August 29, 1977
Re: Indian Point Unit No. 3
Docket No. 50-286

Enclosed herewith is our complete response to your August 12, 1976 information request relating to the effects degraded grid voltage may have on plant operation. An update of the previous partial response which was submitted to you on September 24, 1976 is also included in the attachment.

HYDROGEN INNER-COOLED TURBINE GENERATOR
 CALCULATED CAPABILITY CURVE
 1125.6 MVA, 0.90 PF, 0.50 SCR, 75 PSIG

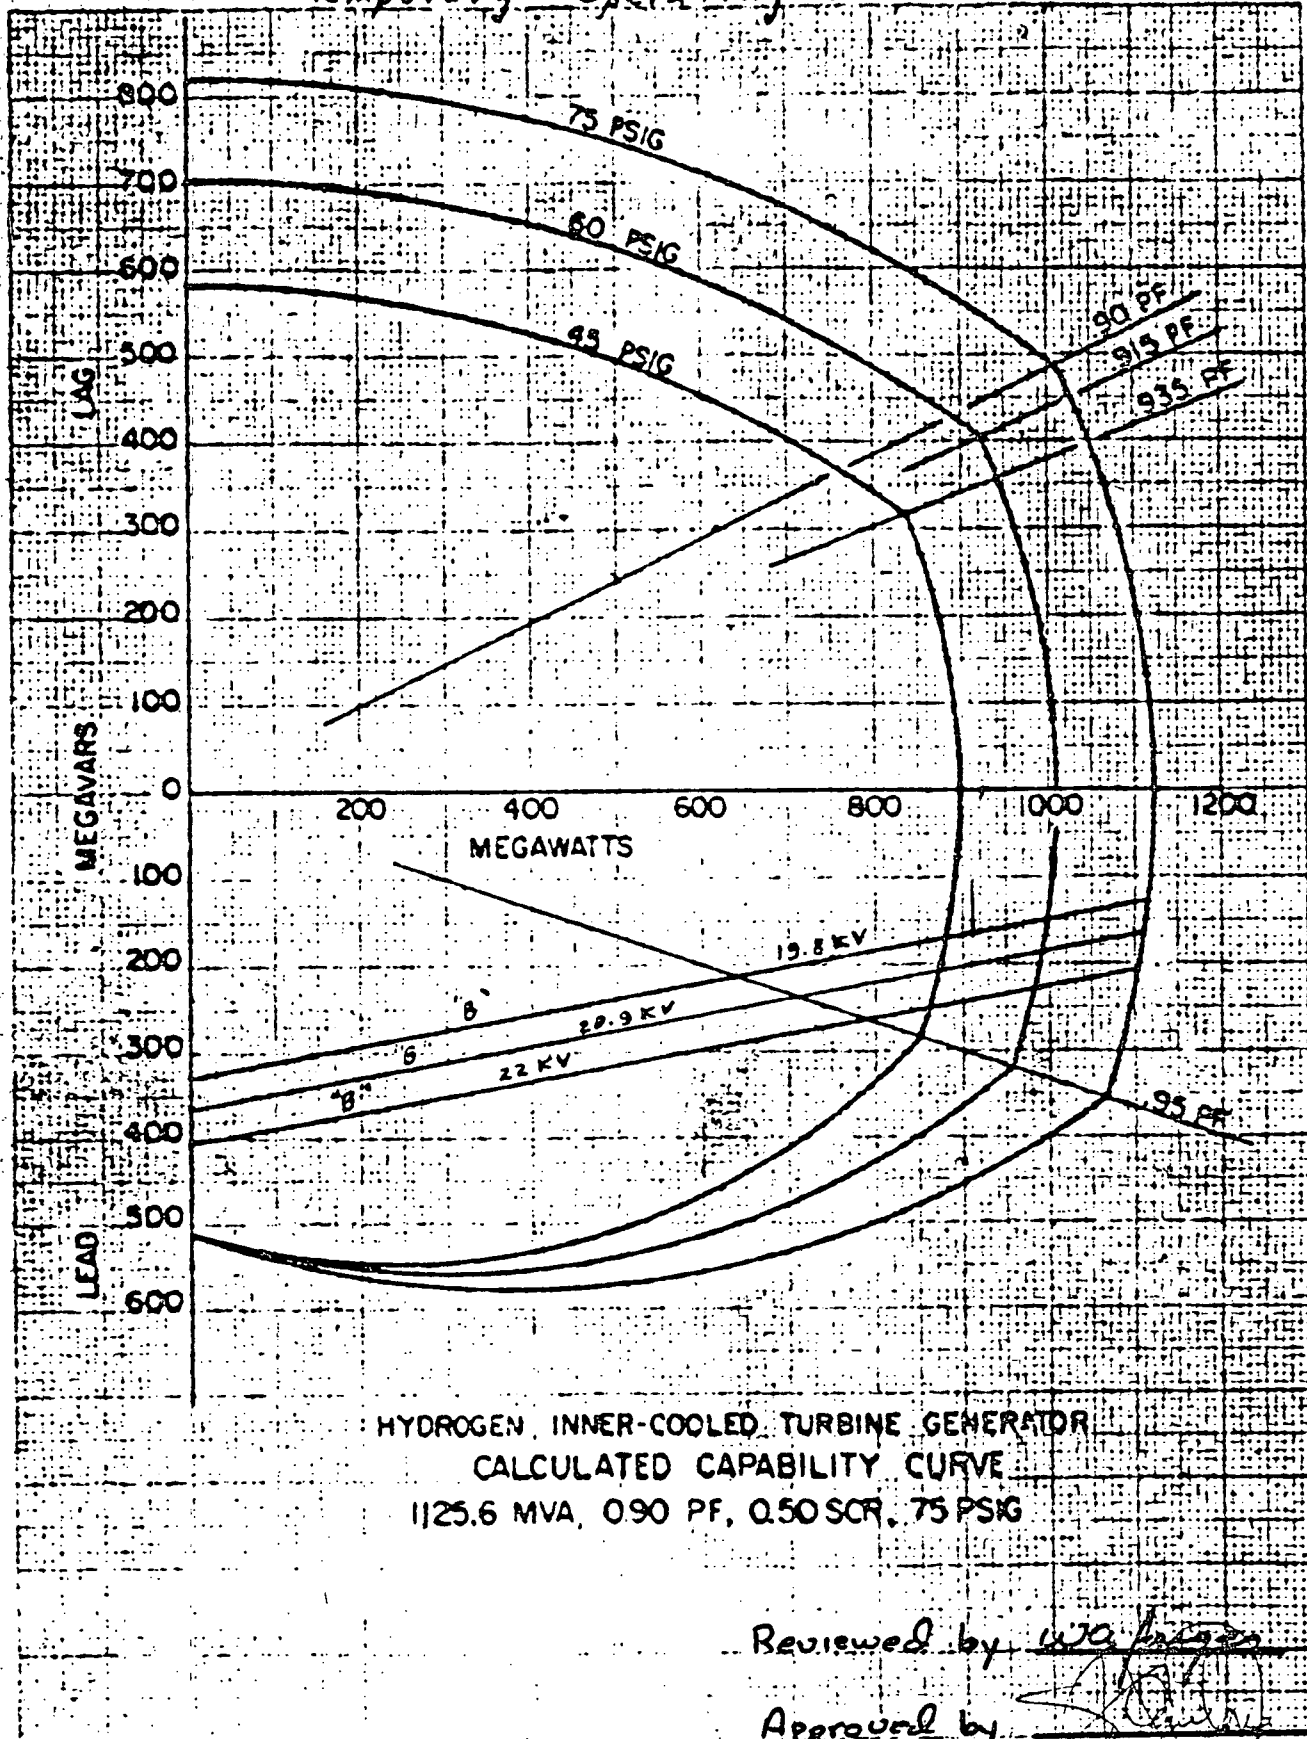
3. Define the facility operating limits (real and reactive power, voltage, frequency and other) established by the grid stability analyses cited in the FSAR. Describe the operating procedures or other provisions presently in effect for assuring that your facility is being operated within these limits.

The operating limits for real and reactive power for Indian Point No. 3 at various hydrogen pressures and generator terminal voltages are given by the Generator Capability Curve as shown in attachment No. 1. The generator may be safely operated anywhere within the region enclosed by these curves.
